MARK	DATE	DESCRIPTIONS	BY	CH'D	CCO#
2	02/24/10	TOWER UTILITY PANELS	JS	RG SYC	70
1	03/30/09	SERVICE PLATFORM ELECTRICAL CHANGES	RR MP	RG FW	55

CONTRACT CHANGE ORDER NO._____
SHEET_____ OF_____

DETAILS
YBI SUBSTATION
480 V LVCC-B SINGLE LINE DIAGRAM
NO SCALE

E-32

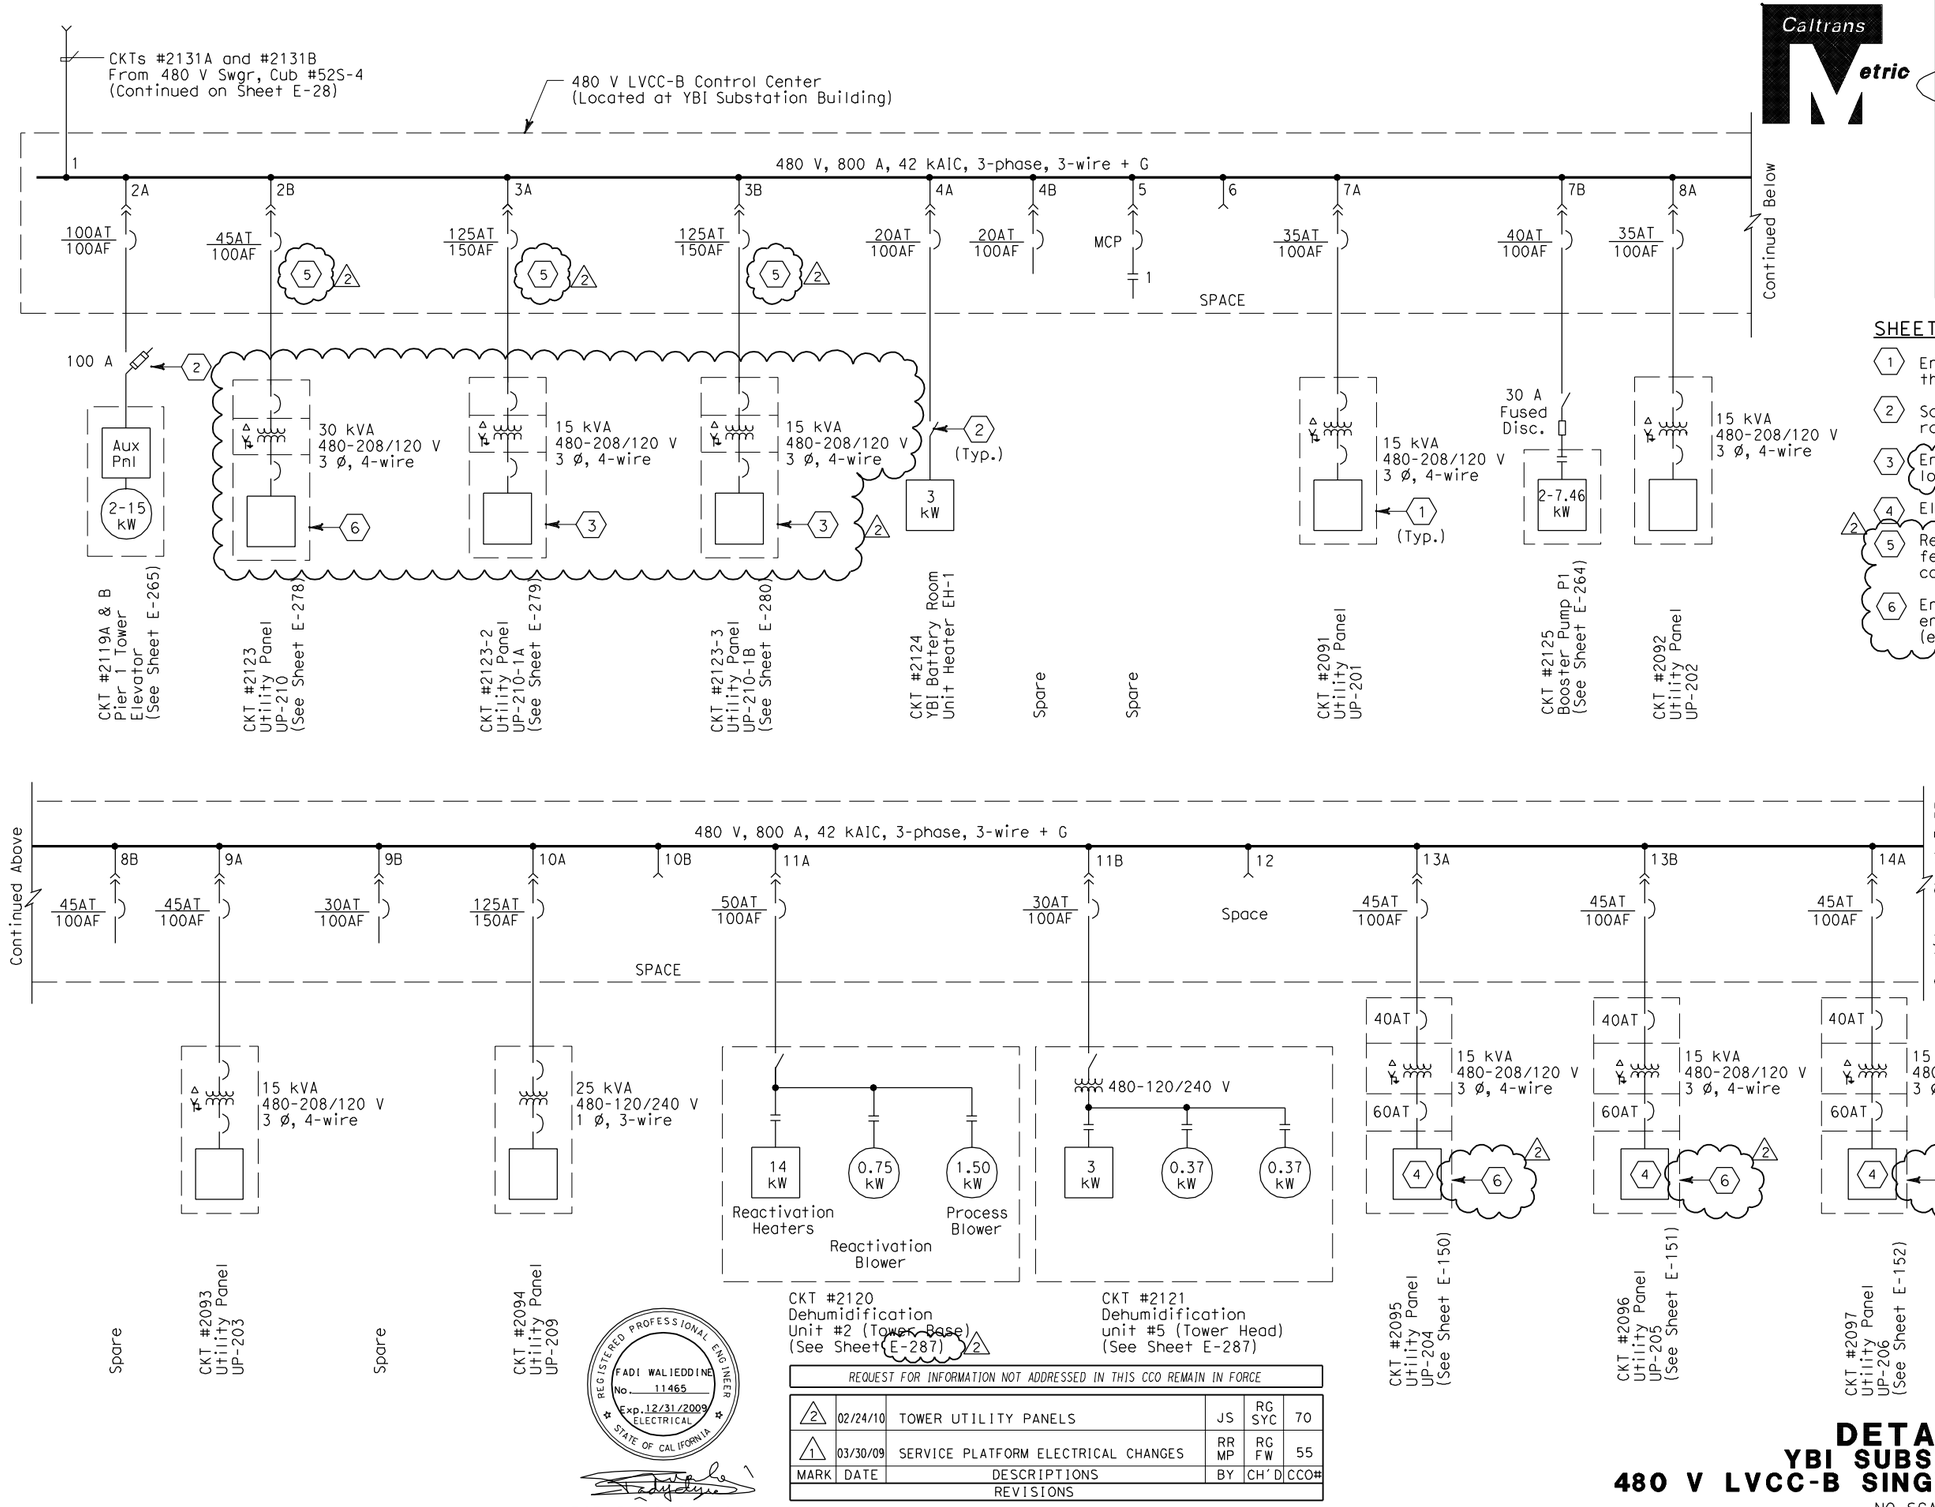
1. Enclosed in a fiberglass enclosure located on the service platform.
2. Safety disconnect switch shall be horsepower rated.
3. Enclosed in separate Nema type 12 enclosures located on the SAS main tower (elev 89.85).
4. Electrical Panel with Main Lugs only.
5. Revision to feeder circuit breaker rating and feeder conductor size accomplished by YBI-1 contract.
6. Enclosed in separate stainless steel Nema 4X enclosures located on the SAS main tower (elev. 53.85) and/or service platforms.
